Seismic Walkdown Checklist (SWC)

Equipment ID No. 1-1605-C5-AS1 Equip. Class¹² 20 (INSTRUMENT & CONTROL PANEL)

Equipment Description EAGLE 21 DUAL COMPARTMENT SEISMIC CABINET

Location: Bldg. CONTROL Floor El. 240' Room, Area R 267^{11/14/12} R 230

Equipment ID No. 1-1605-Pr-SDB Equip. Class¹² 20

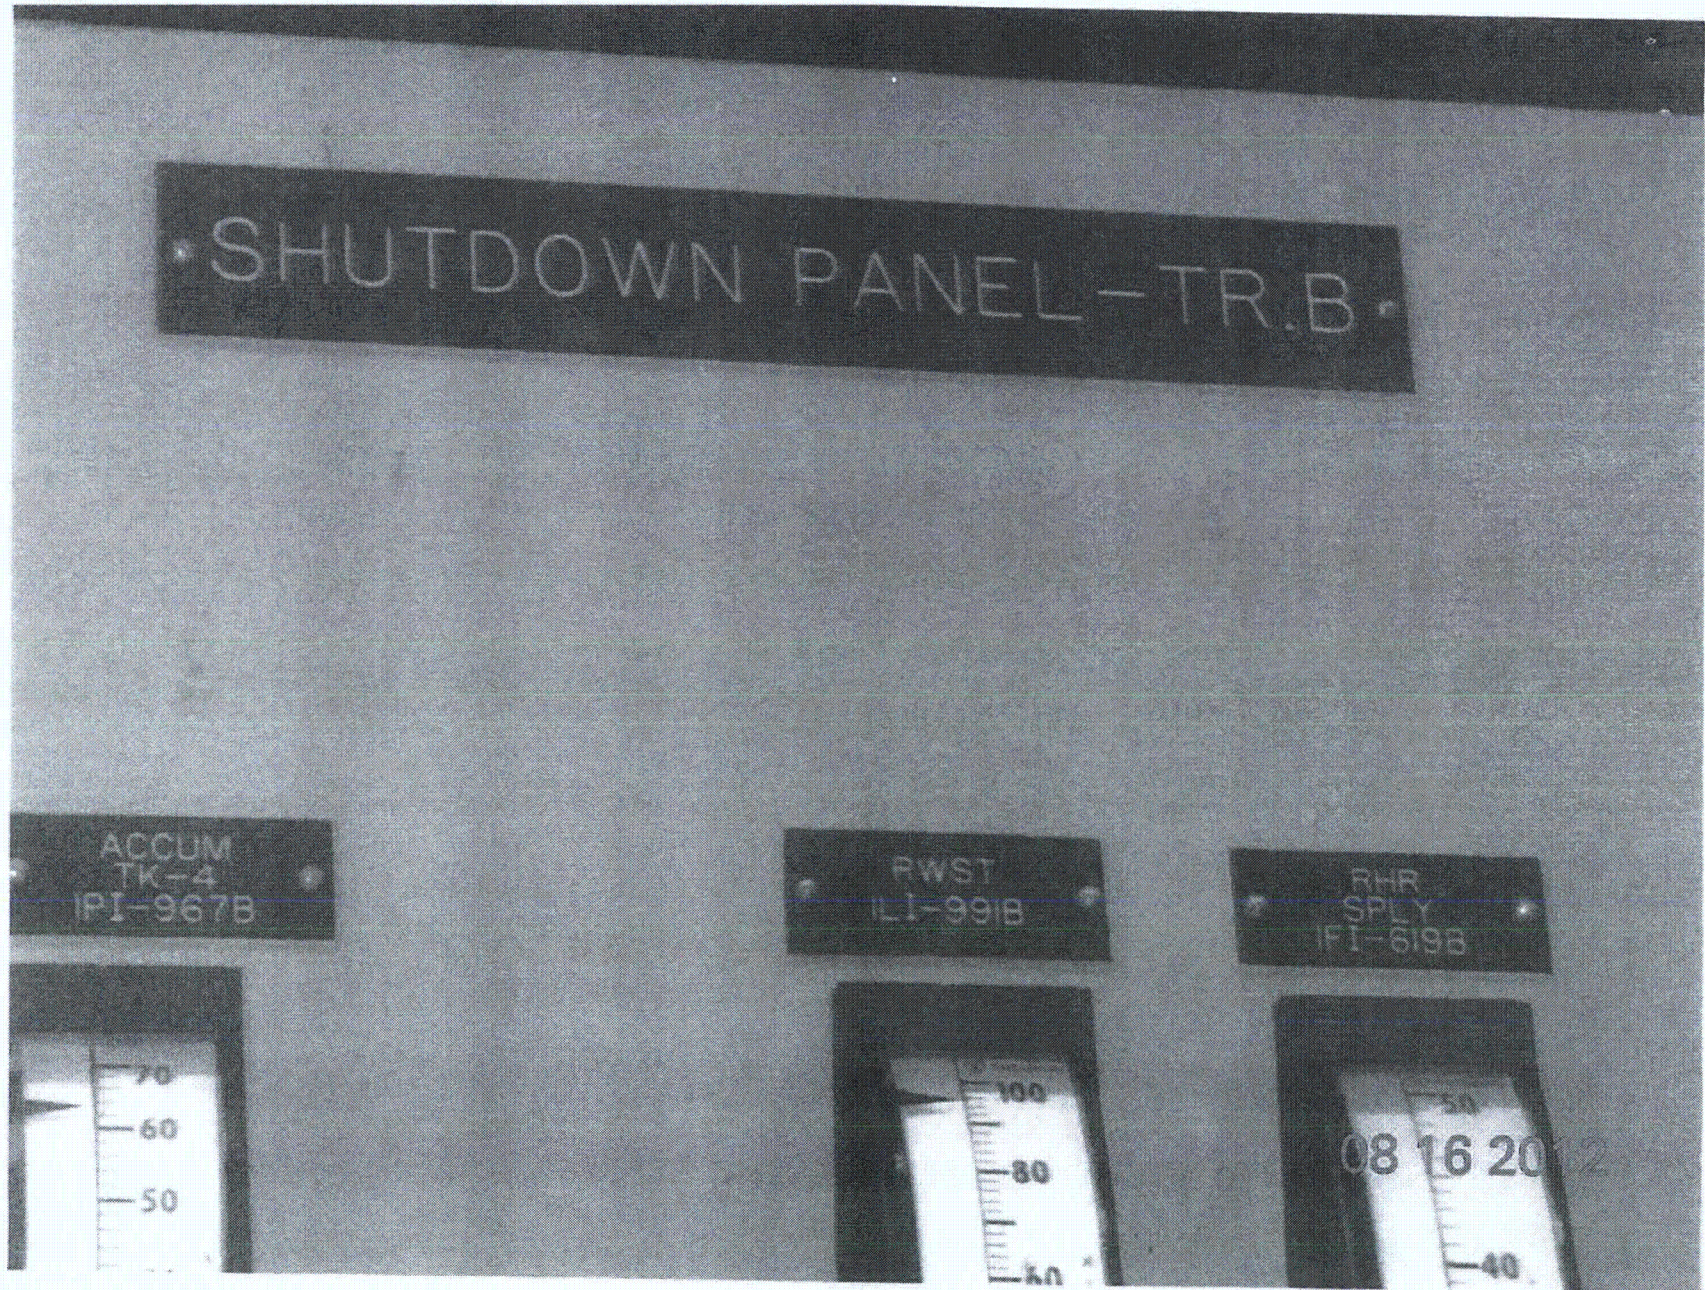
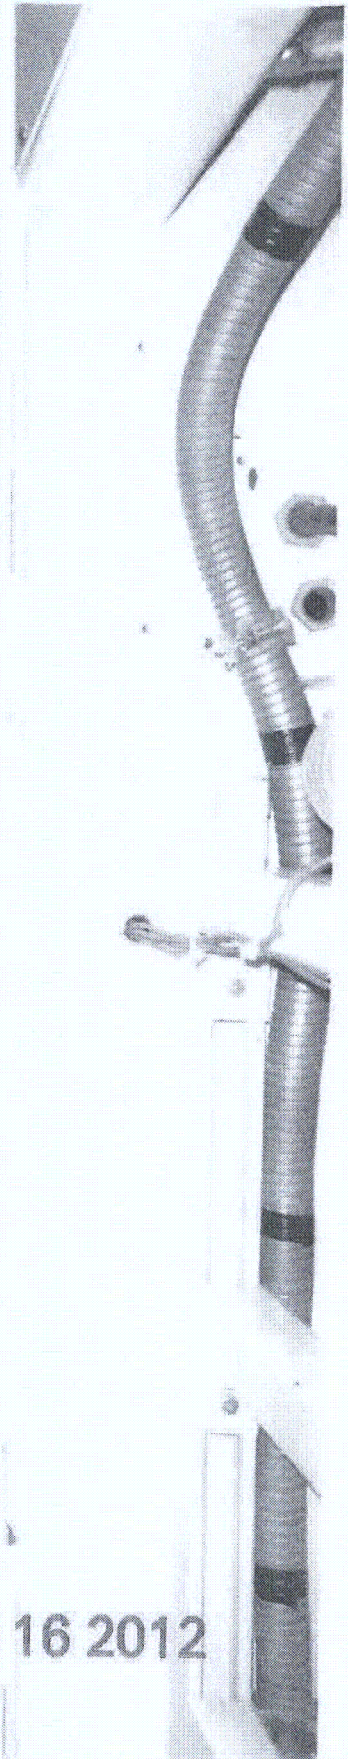
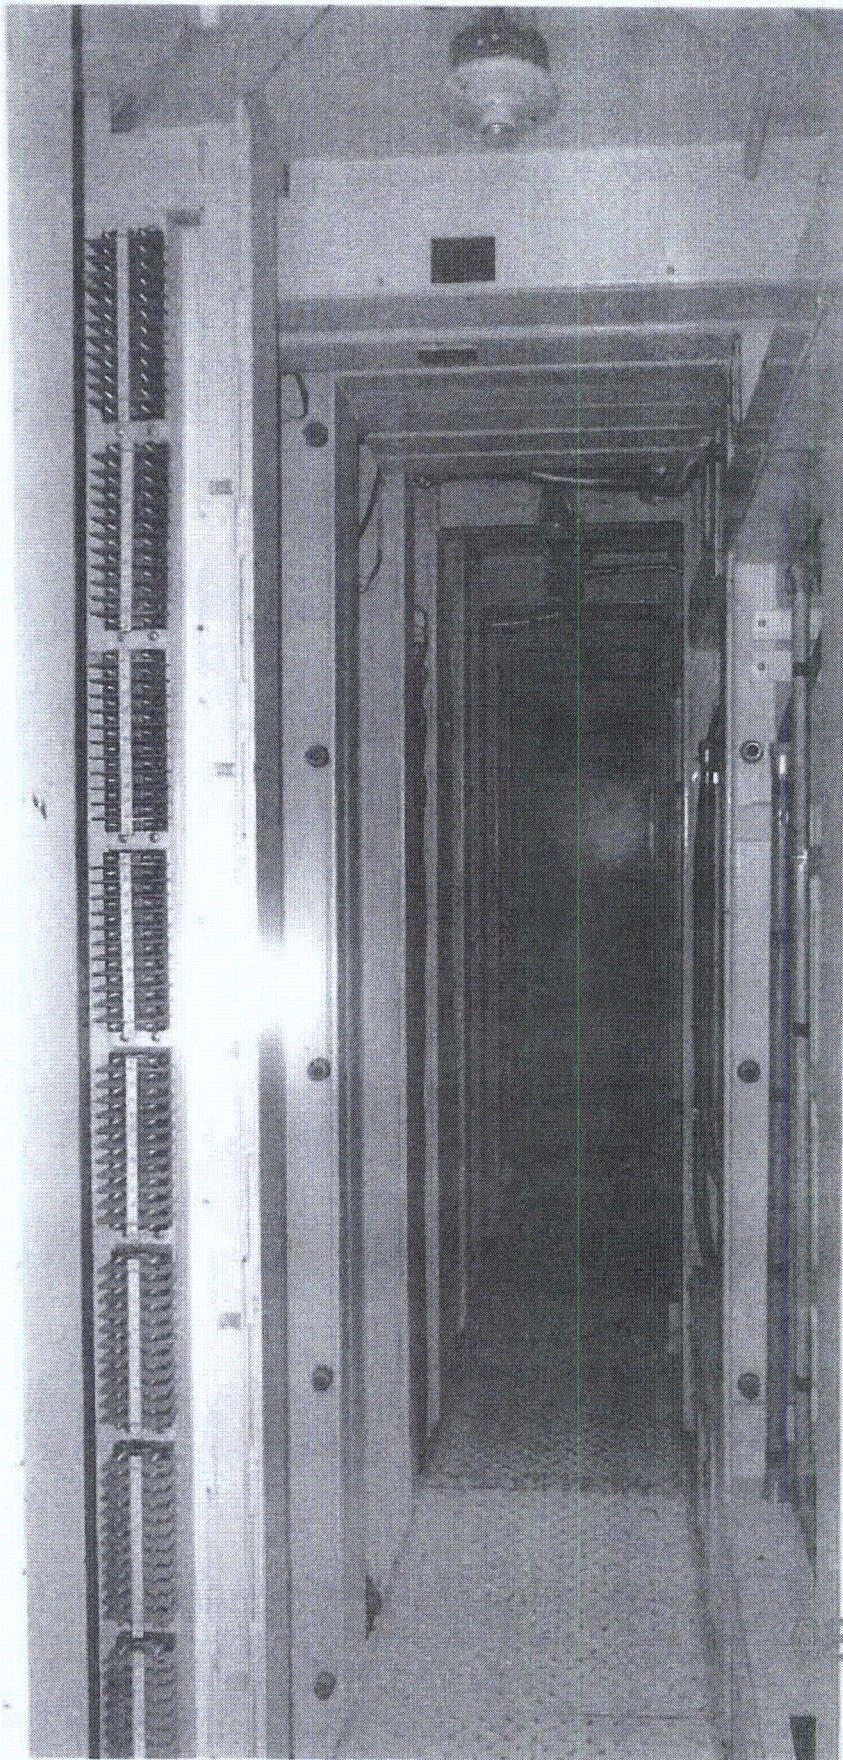
2. Is the anchorage free of bent, broken, missing or loose hardware? Y N U N/A
Shutdown panels are welded to embed steel

3. Is the anchorage free of corrosion that is more than mild surface oxidation? Y N U N/A
welds have no cracks and free of corrosion

4. Is the anchorage free of visible cracks in the concrete near the anchors? Y N U N/A
panels welded by plates embed

By opening side door, bolted connection between panels are in good conditions.
